### PROFILE FISH LADDER MODIFICATION (LOWER WEIR POOLS)

PROJECT NO. US-OR-32-8	DATE: 12/14/16	DESIGNED BY: GW
METRO: SMITH BYBEE		DRAWN BY: DMC
		SURVEYED BY:
		CHECKED BY:
		SHEET NO. 4 OF 8
WCS IMPROVEMENTS

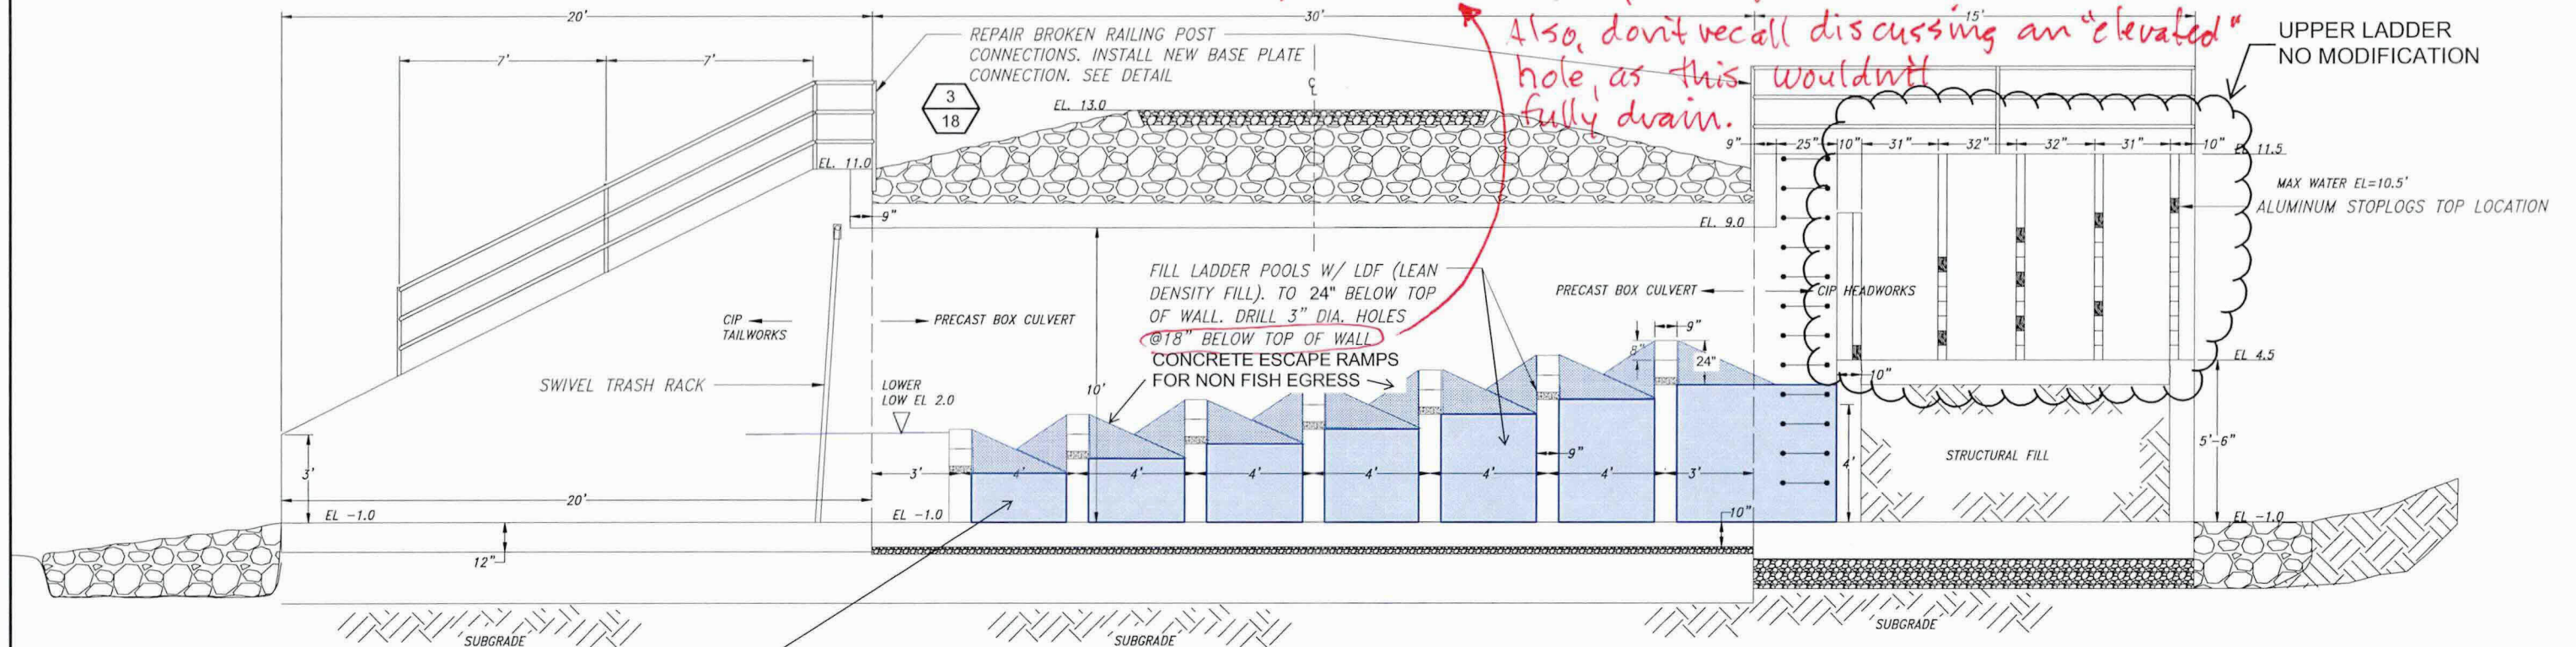
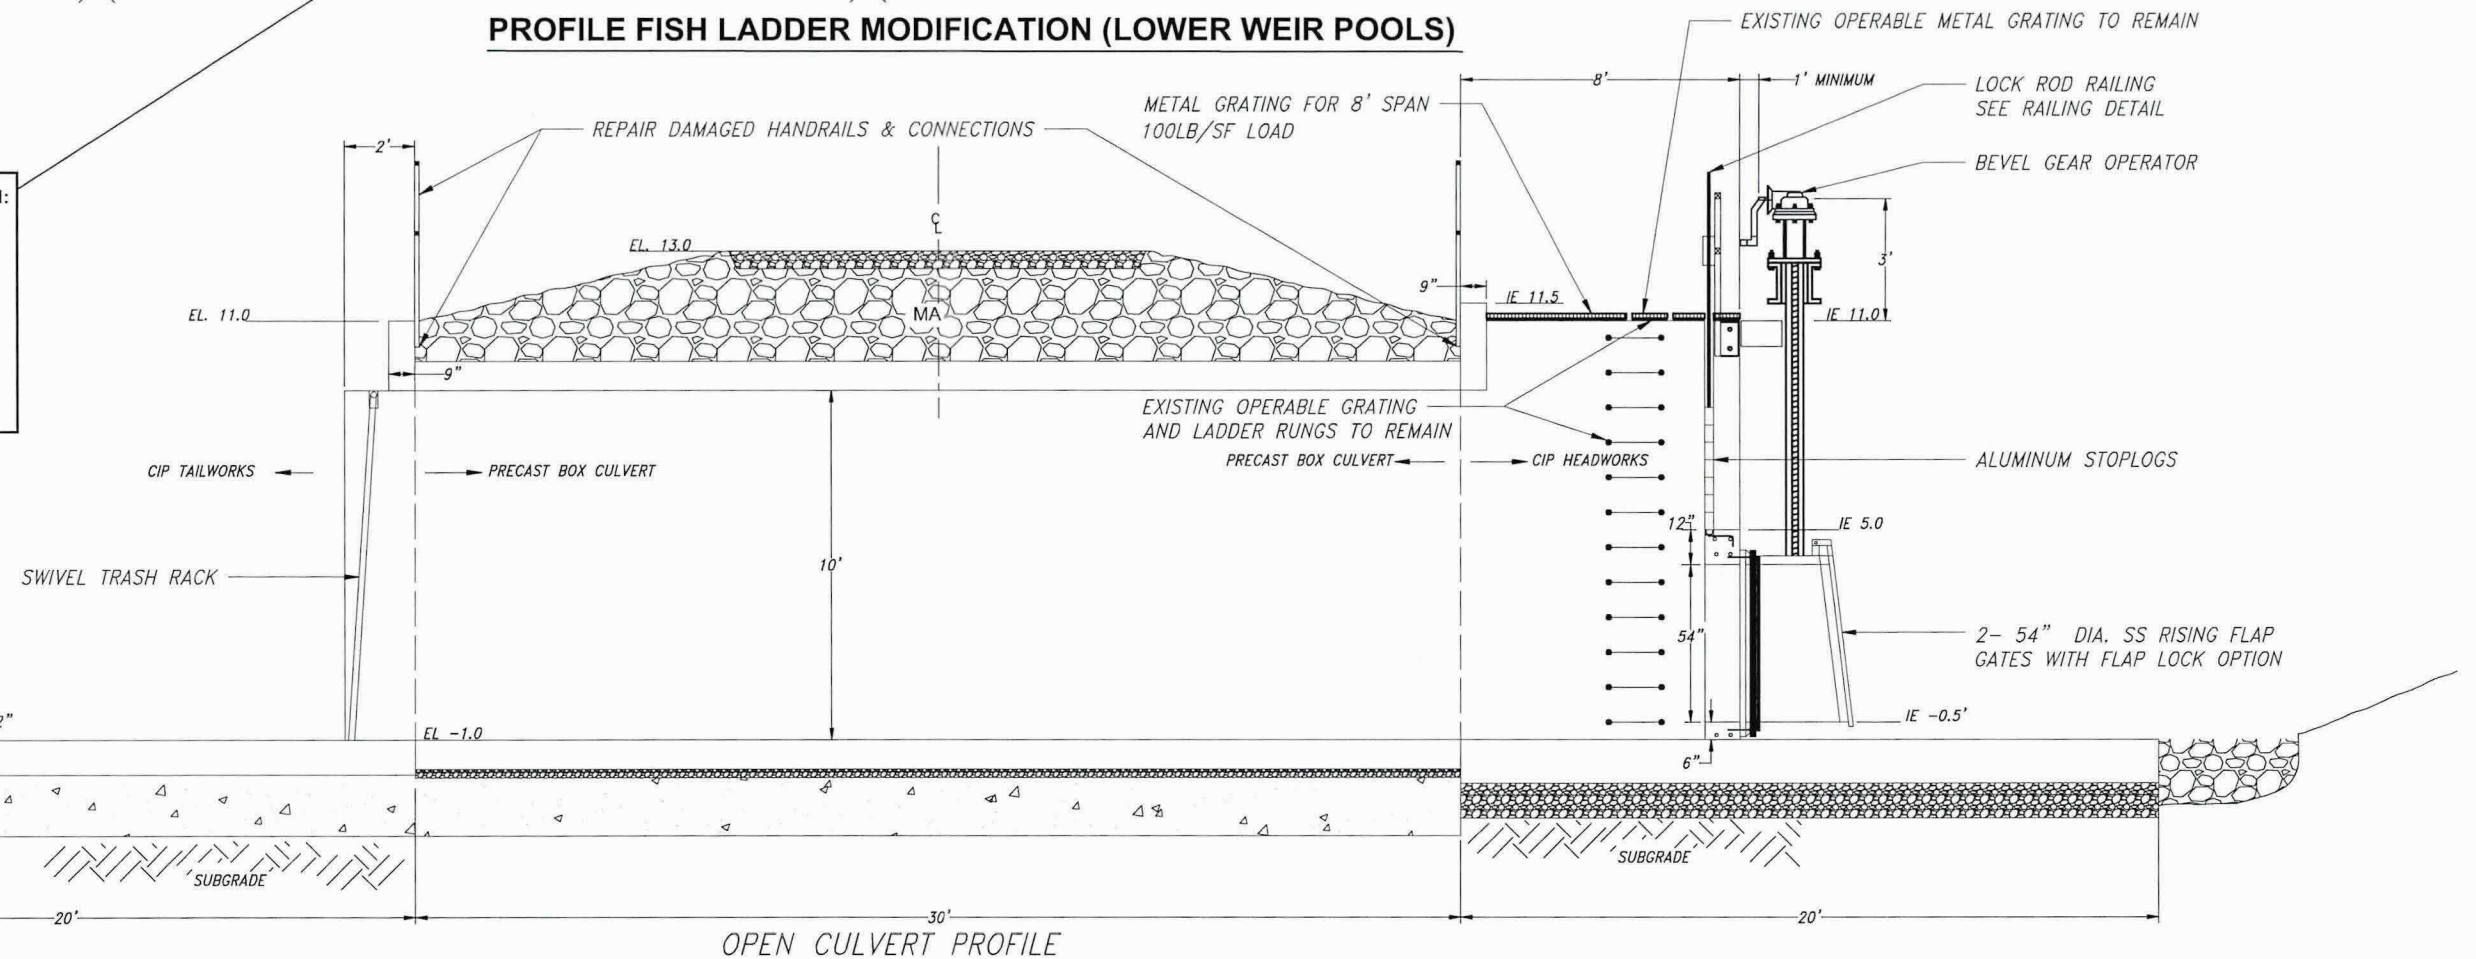
Diagram seems to show holes at base of LDF i.e. 24" below top of wall.

Also, don't recall discussing an "elevated" hole, as this wouldn't fully drain.

**1 WCS IMPROVEMENTS  
WCS PLAN VIEW**

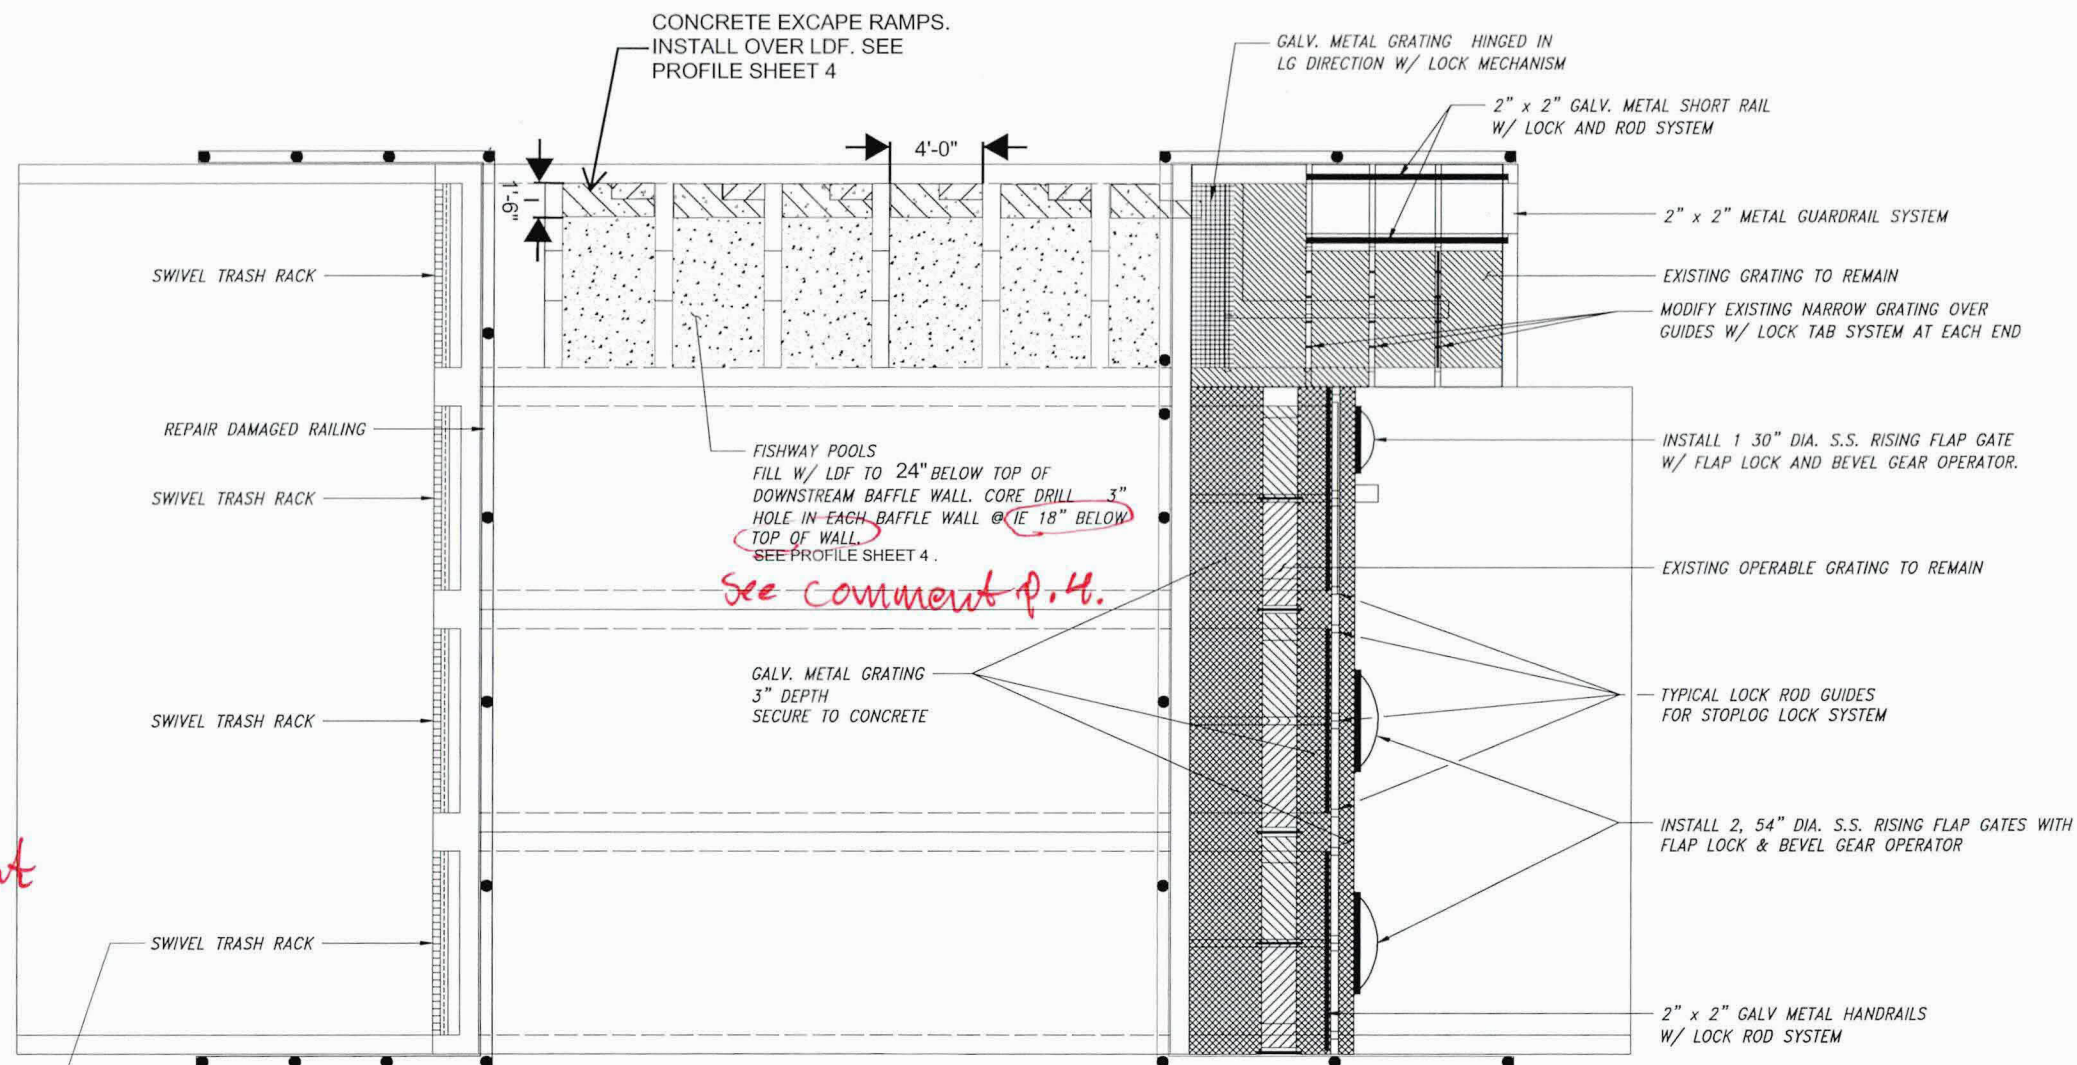
See  
comment  
p.4
